# Access Compliance Report

## Public Rights-of-Way

### (Curb Ramps)

Intersection ID: 43525	Main Street: MILHAVEN_LN	Cross Street: TANAGER_PARK_DR	Location: NW
ADA ID: 3D25F3513BE7	Ramp Type: Para	Initial Pass/Fail: Fail	Overall Compliance: No
Severity Score: 13.75			
Codes/Mitigation Info/Possible Solution		Field Measurements/Component Compliance

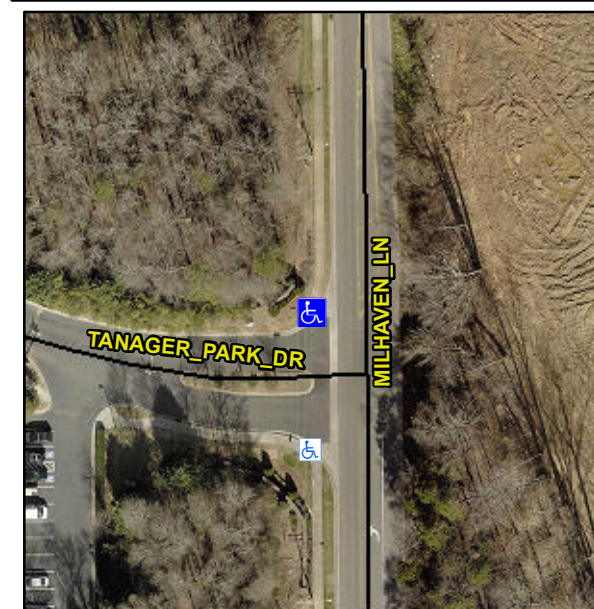
**R304.3.2, R304.5.3**

Compliance	Description	Data	Compliance	Description	Data
N/A	Ramp Length LT (in)	57.0	N/A	Ramp Length RT (in)	108.0
Yes	Ramp Width LT (in)	60.0	Yes	Ramp Width RT (in)	59.5
No	Ramp Slope LT (%)	8.7	Yes	Ramp Slope RT (%)	7.9
No	Ramp XSlope LT (%)	2.4	Yes	Ramp XSlope RT (%)	0.7
N/A	Landing Length (in)	N/A	N/A	DWS Provided?	N/A
N/A	Landing Width (in)	N/A	N/A	DWS Contrast?	N/A
N/A	Landing Slope (%)	N/A	N/A	DWS Length (in)	N/A
N/A	Landing X Slope (%)	N/A	N/A	DWS Full Width?	N/A
N/A	Landing Curb? (Y/N)	N/A	N/A	DWS Offset (in)	N/A
N/A	Shared Landing?	N/A			
N/A	Gutter Ponding?	N/A	N/A	Gutter Slope (%)	N/A
N/A	Gutter Lip Ht (in)	N/A	N/A	Gutter X Slope (%)	N/A
N/A	Painted X Walk1?	No	N/A	Painted X Walk2?	N/A
	X Walk 1 Direction	To S		X Walk 2 Direction	N/A
N/A	X Walk 1 Width (in)	N/A	N/A	X Walk 2 Width (in)	N/A
	X Walk 1 Slope (%)	1.0		X Walk 2 Slope (%)	N/A
	X Walk 1 X Slope (%)	0.3		X Walk 2 X Slope (%)	N/A
N/A	Ramp inside XWalk1?	N/A	N/A	Ramp inside XWalk2?	N/A

**Remove & Replace Entire Ramp.**
